# TECHNICAL BULLETIN

## UPGRADE NOTICE FOR 3300/WIN3300 SOFTWARE V2.1

These Examples are for Software Versions 2.0 and Below

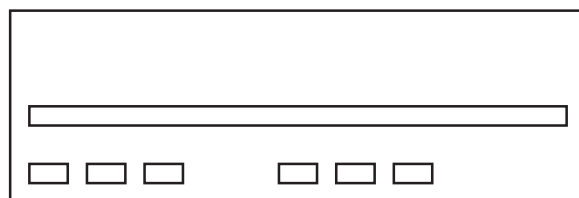
If you are upgrading the software in your 3300 Controller from V2.0 or earlier to V2.1 or later and use Cougar Audio Routing Switchers or Cougar Video Routing Switchers in your system configuration, you must increment the level codes on each Cougar Routing Switcher Frame by 1. The level code values are binary encoded on the LVLCODE DIP Switch. To adjust the level code, you add one to the current LVLCODE value encoded on each LVLCODE DIP Switch.

A switching system is configured with a Cougar Video Routing Switcher and a Cougar Audio Routing Switcher. The Win3300 Control System software program has set the Cougar Frames to use strobe 1 for video and strobes 2 and 3 for audio. The actual switching matrixes are set up with the Cougar Frames encoded for video at LVLCODE 0 and the audio at LVLCODEs 1 and 2.

The new version of software requires that the Cougar Frame LVLCODE DIP switch settings be incremented to where the video level code is set to LVLCODE 1 and the audio level codes are set to LVLCODE 2 and LVLCODE 3.

Note that now the strobe settings in the Win3300 Control System program match those physically set at the Cougar Frame!
